Docket Item # 4 & 5  
BAR CASE # 2011-0282  
2012-0023

BAR Meeting  
February 22, 2012

**ISSUE:** Request for construction of 39 townhouses and 4 triplexes in Phase III of the James Bland Redevelopment Project, *and*

Request for construction of three multi-family buildings, 27 townhouses, four triplexes and a park in Phase V of the James Bland Redevelopment Project and

Figure 7. Section through proposed multi-family buildings.

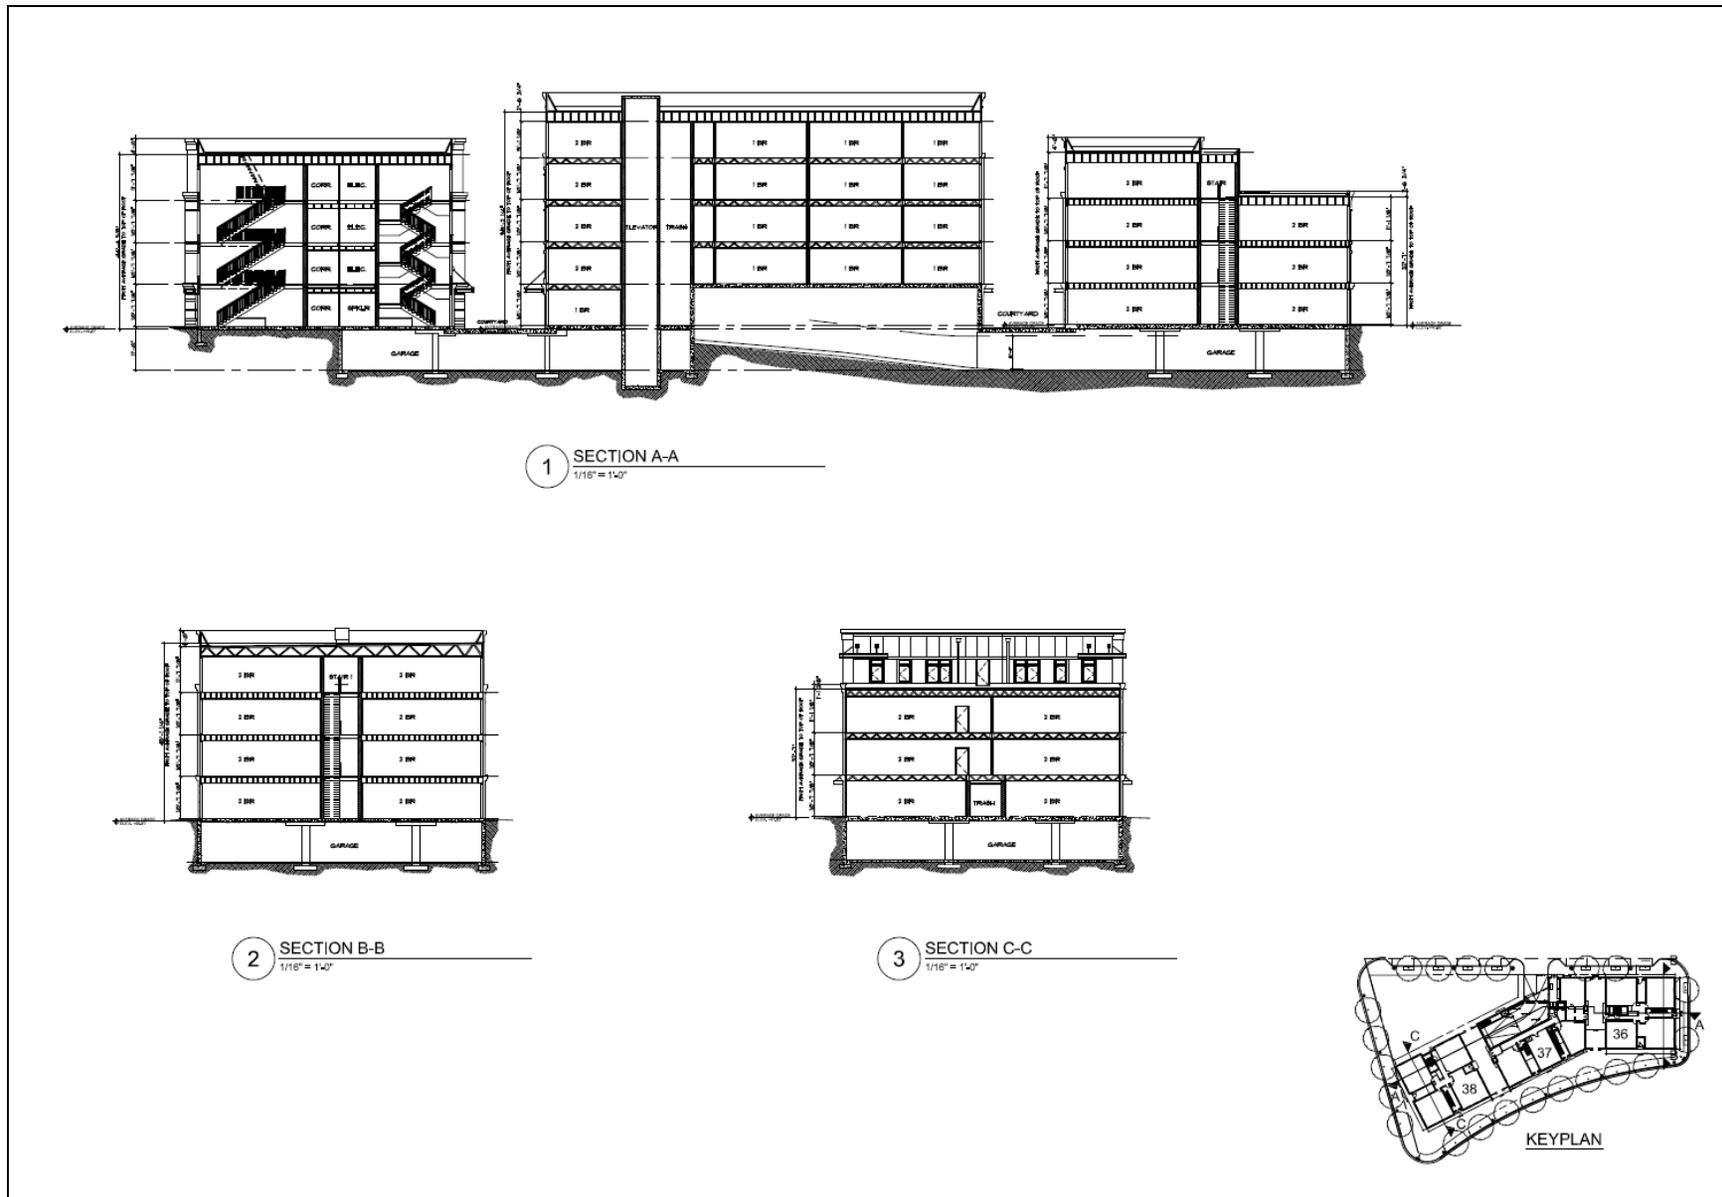
There appears to be a disproportionate area of HardiePanel in this area that leads to an over-scaling of this element at the top floor. *Staff recommends that this element be refined through a reduction in the area of HardiePanel above the top story windows. Staff recommends that the applicant carry the use of brick to the top of the fourth story windows and to add a lintel/continuous band above the windows using Hardie material. This revision will minimize the total area of HardiePanel and allow for a smaller area of Hardie that will read as a more classical frieze with a cornice above. Staff is sensitive to the additional costs but notes that the additional brick area proposed is minimal. It may also be necessary to restudy the location of belt courses/window sills at this fourth floor level to readjust the proportions once the brick is raised. Staff recommends that the Board allow the applicant to work with Staff for final approval of this revised scheme.*

1. That the applicant extend the brick to the top of the fourth-story windows and reduce the area of HardiePanel between top-story windows and the cornice for the southernmost building with final approval by Staff;
2. That the visual impact of the proposed accessibility ramp on Montgomery Street be as minimal as possible, with final approval by staff;
3. That the mechanical equipment be grouped in the center of the roof to the maximum extent possible to minimize visibility from the surrounding streets and that all stickers, labels and markings not required by the manufacturer be removed from all mechanical equipment.

Figure 15. Cornice details.

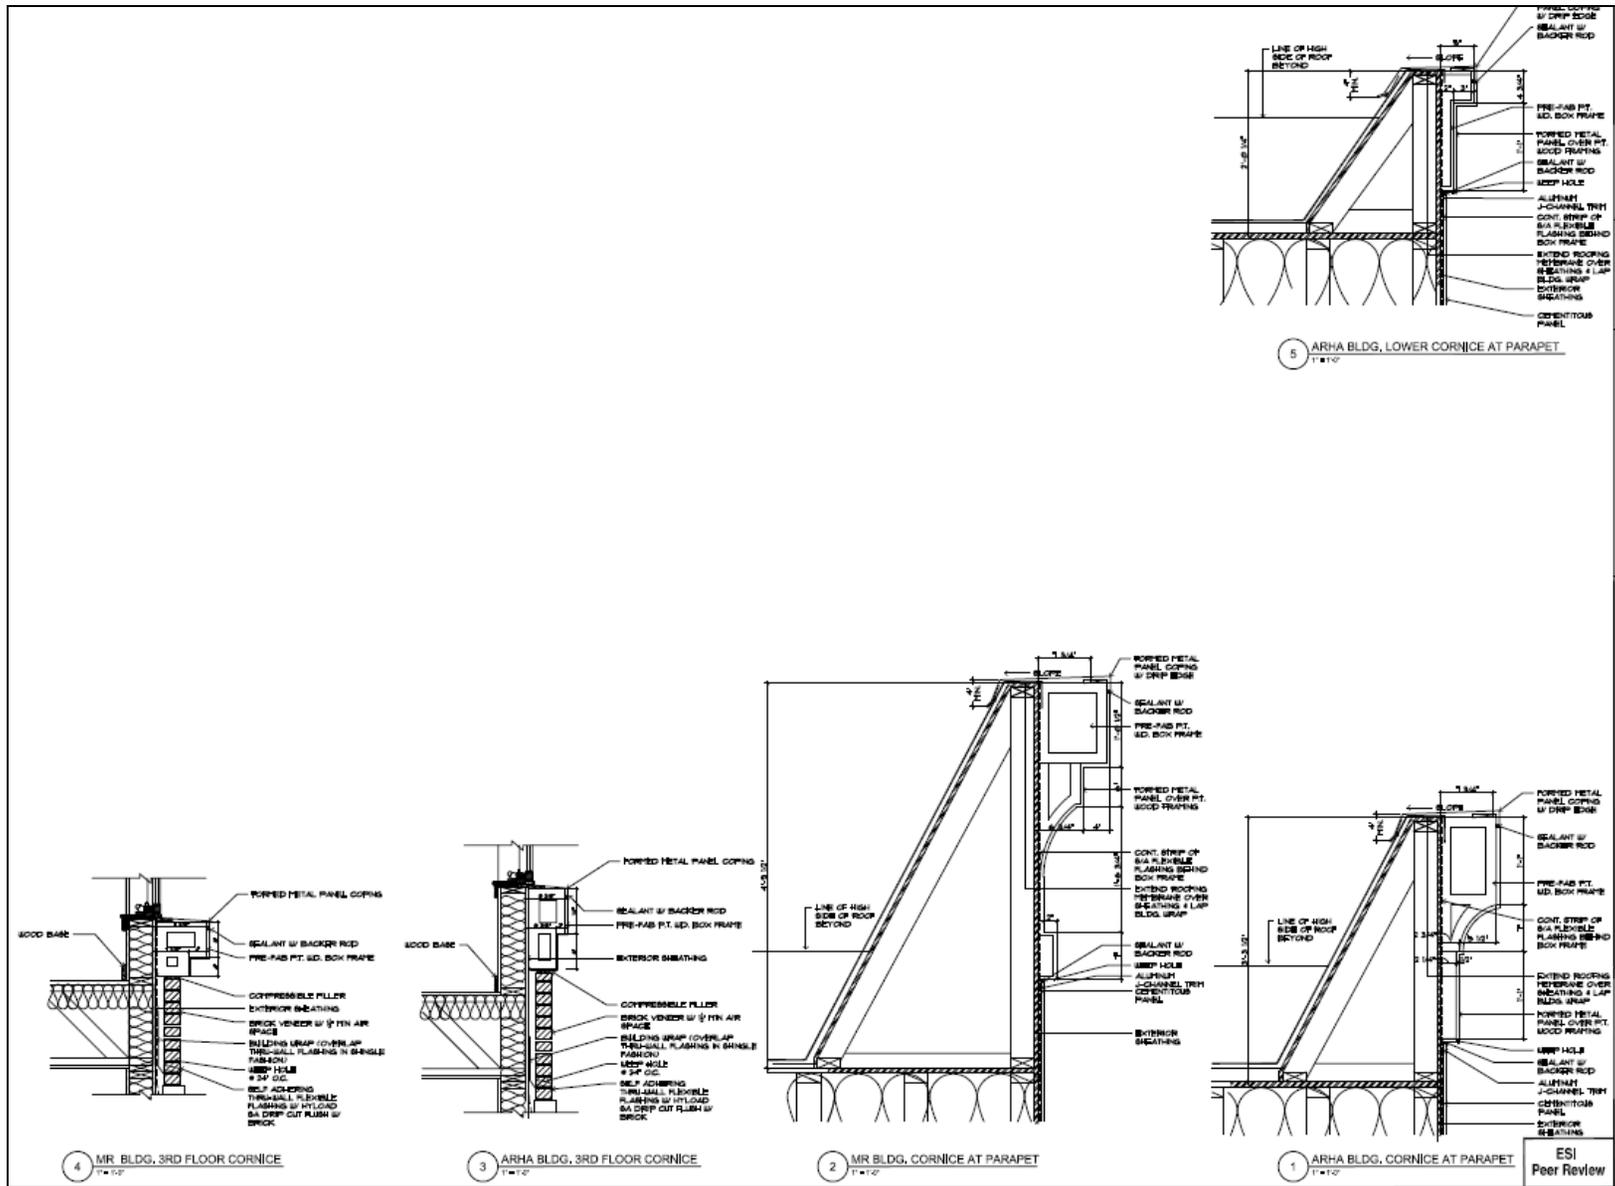
Chairman Conkey suggested that the applicant bring the brick farther up, raise the windows a few inches and bring the cornice down at Building 36 to reduce the overpowering fourth story. He also questioned the use of downspouts in place of roof drains and noted that downspouts are not appropriate on a masonry building of this scale. He commented it was odd to have small building elements, such as downspouts, on big buildings such as these. He also noted that the detailing of these buildings will be important and that the industrial aesthetic could be successful with the right detailing. Chairman Conkey found all three proposed brick colors to be appropriate though suggested the applicant also consider a brick color with iron spots (orange spots) to add life. He agreed with concerns raised by other Board members about Building 36 and

5. That the applicant work with Staff on the text and graphics of the historical marker and conform to the standards set forth in the City's recently adopted Wayfinding Program (previous BAR condition).
6. That the applicant work with Staff to determine the least obtrusive location for the mail boxes (previous BAR condition).
7. That the applicant adequately screen all utilities and trash receptacles from the street (public or private). Where illumination is required for utility and trash areas, the light fixtures should be discreet and unobtrusive (i.e., not goosenecks), with final approval by Staff (previous BAR condition with modification).
8. That the applicant reduce the cornice projection as discussed in previous phases.
